ADDENDUM No. TWO

Project Name: Holts Landing Boardwalk & Trail Improvements
 Holts Landing State Park

Project No.: HL-10C

Date of Issue: February 20, 2019

PROJECT NOTES & LEGEND

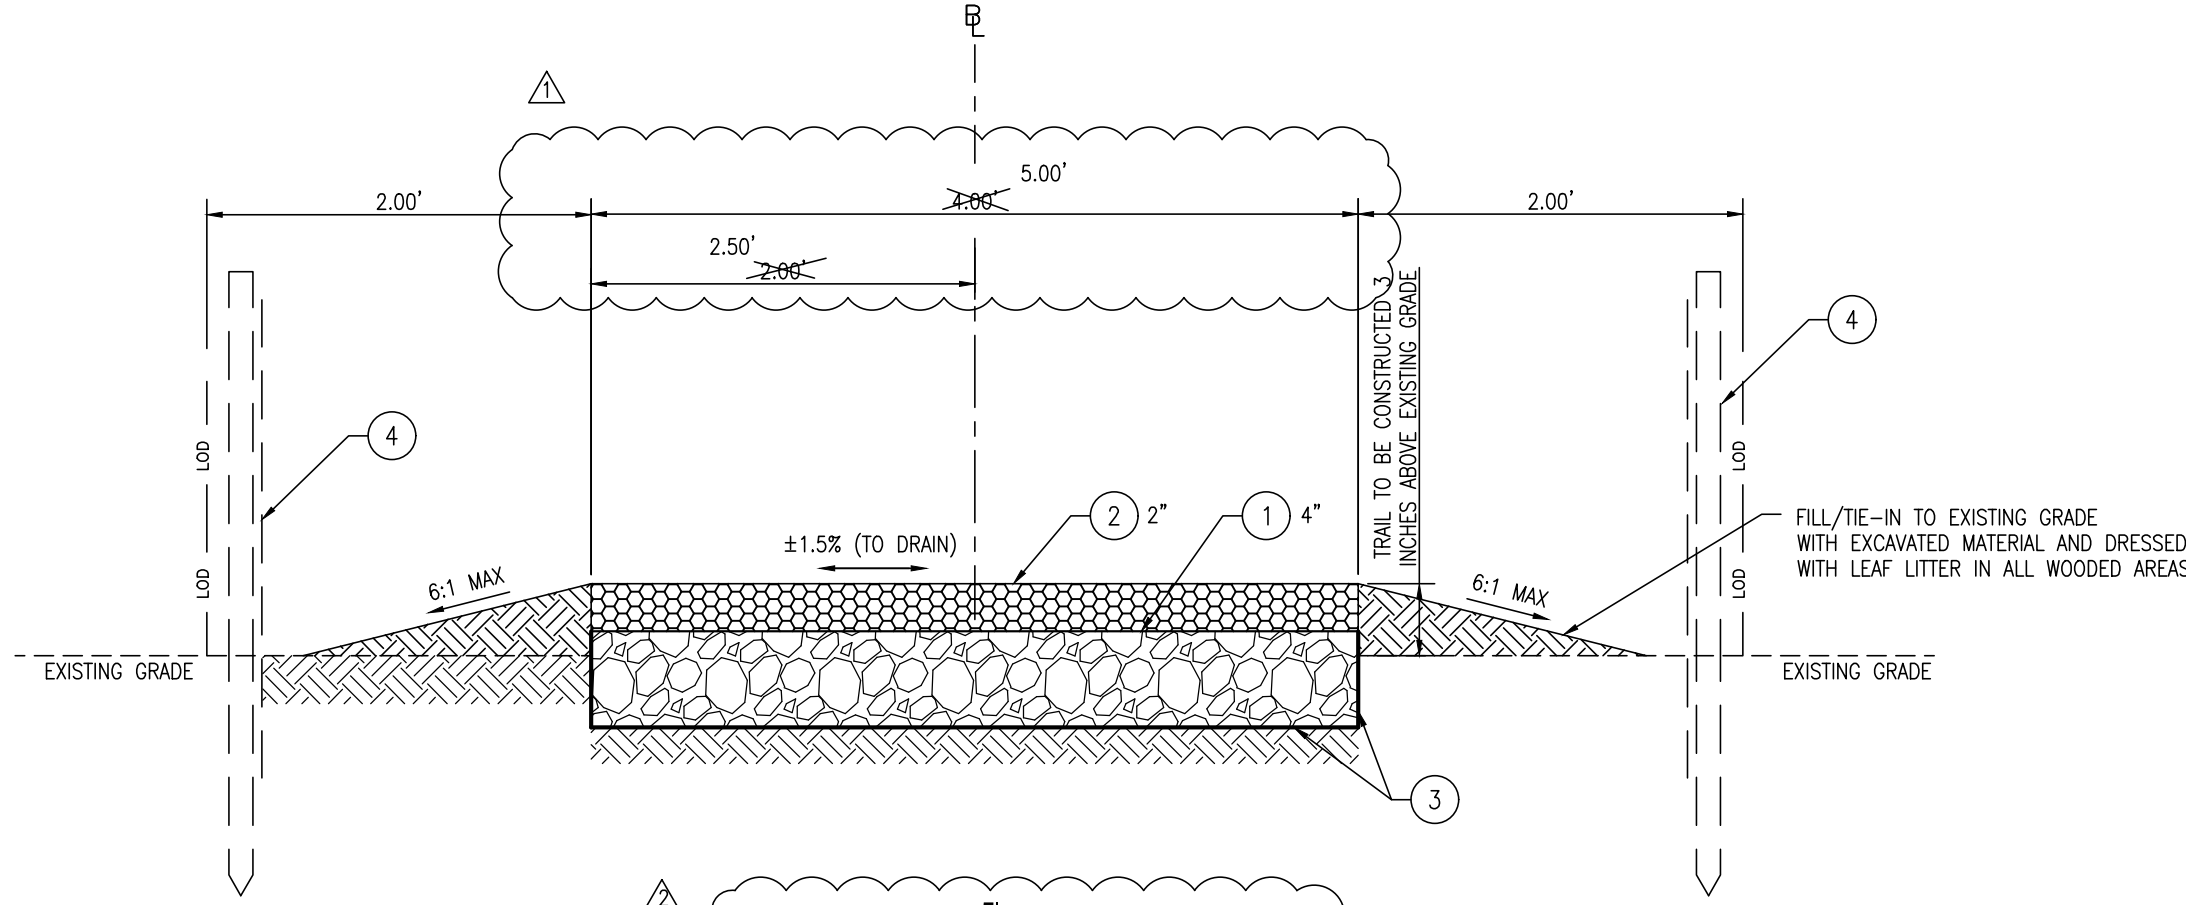
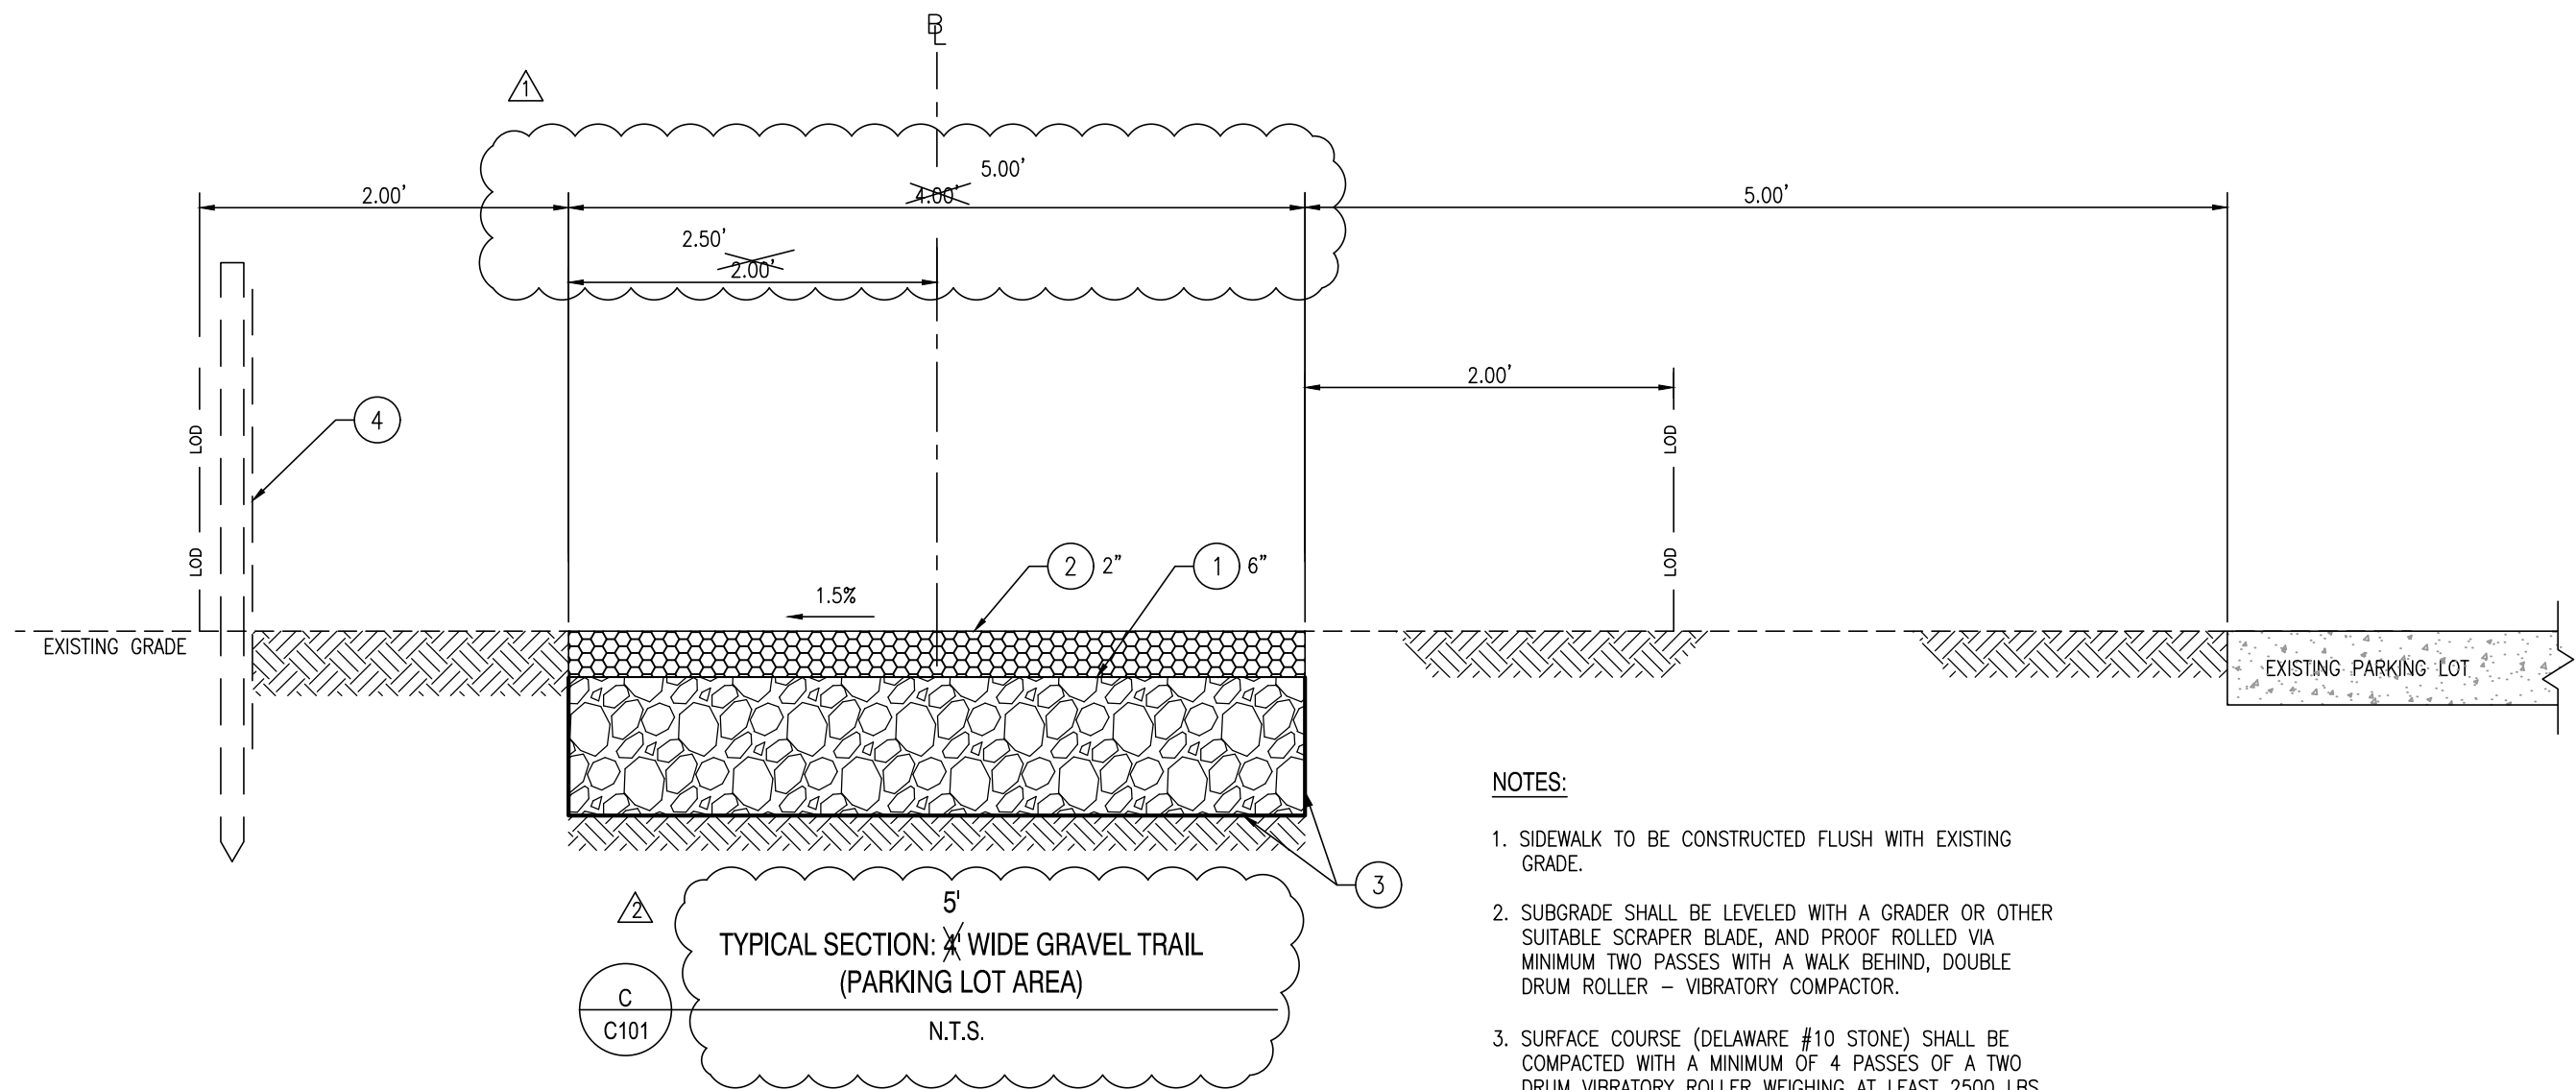
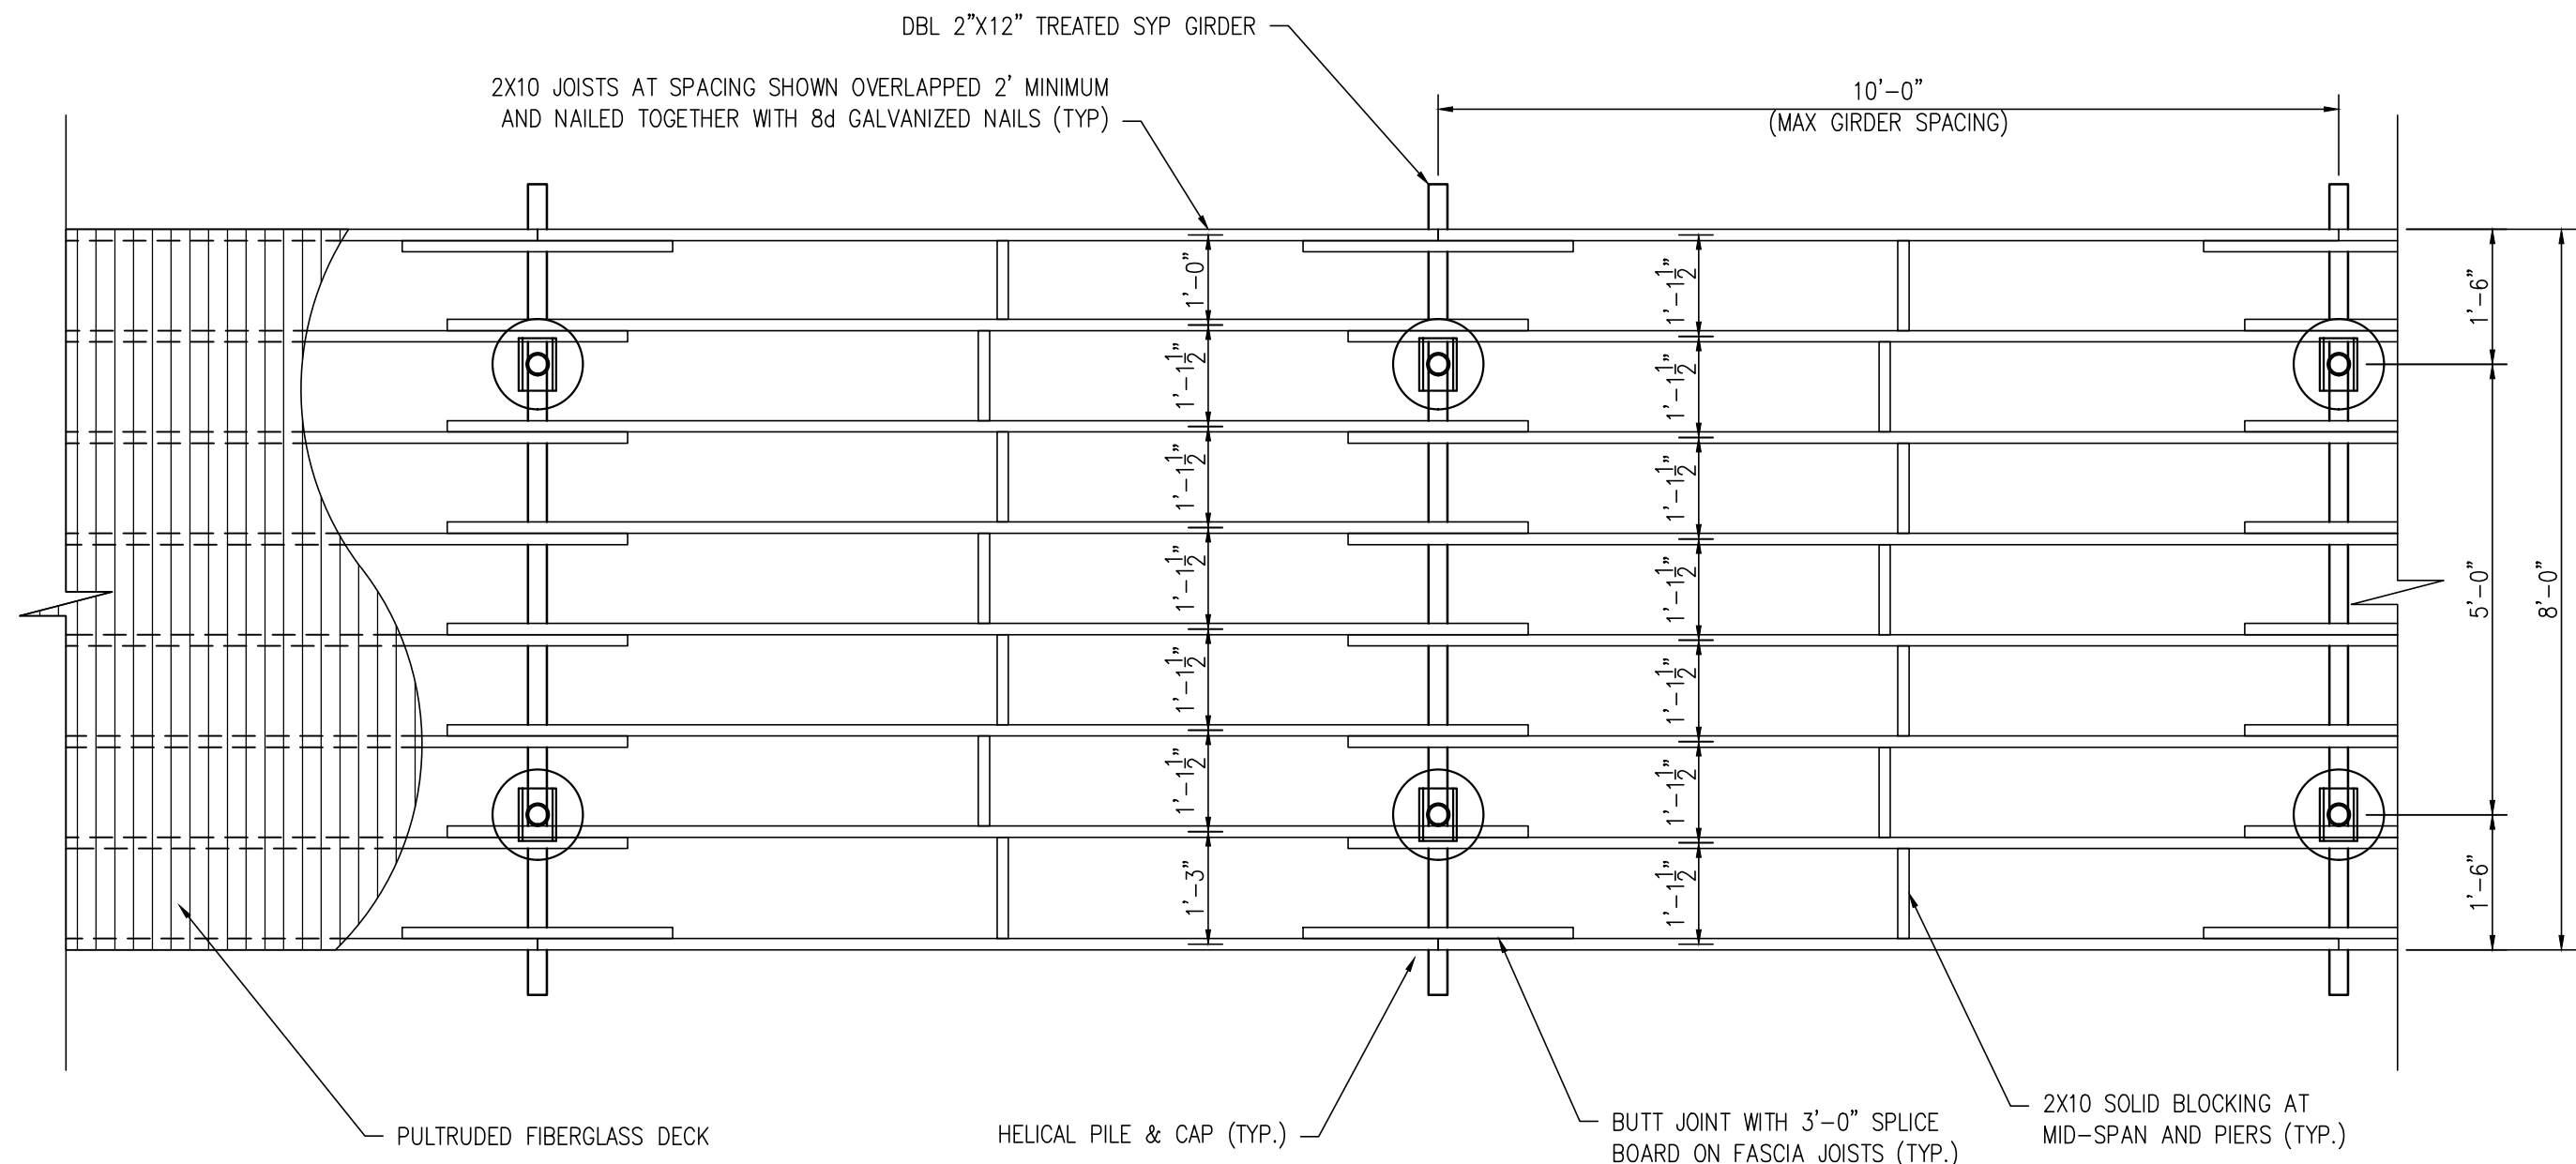
1. Plan Sheet C301: Added Project Notes and Legend
2. Plan Sheet C308: Note revision to the Pultruded Fiberglass Decking

2. Can a 8" dia. silt Sox as per sheet SSMP502 detail # DE-ESC-3.1.7 be used instead of the 18" dia. as per sheet # C301, Item legend note #4?

3. Please clarify as to the LF of trails that are in the base bid. Plan sheet C301 Project Note # 1. , 1.3 has 629' of trail along southern edge of existing parking lot. Note # 2 (addendum #1) the base bid shall include an additional 1200' trail. Now is this 1200' trail in addition to the 629' trail?

7. The plans should provide **elevation profiles** along proposed alignments 1,2,3,4 & 5.

A: Yes, an 8 inch diameter Compost Filter Log is allowed instead of the 18 inch Compost Filter Log.

A: Yes, the 1200 L.F. of gravel trail noted in Addendum #1 is in addition to the 629 L.F. of trail already identified on the Contract Plans.

A: Alignments 1, 2, and 3 are to be constructed per detail A on Sheet C301, following existing grade. Alignments 4 and 5 are to be constructed using the elevation shown on Sheet C307, using the Parking Lot as a starting elevation for Alignment 5 and using an 18 foot long 12:1 slope from existing grade to reach the starting elevation of the boardwalk.

DATE: 2/12/2019
DESCRIPTION: ADDED PROJECT NOTES 2 AND 22.
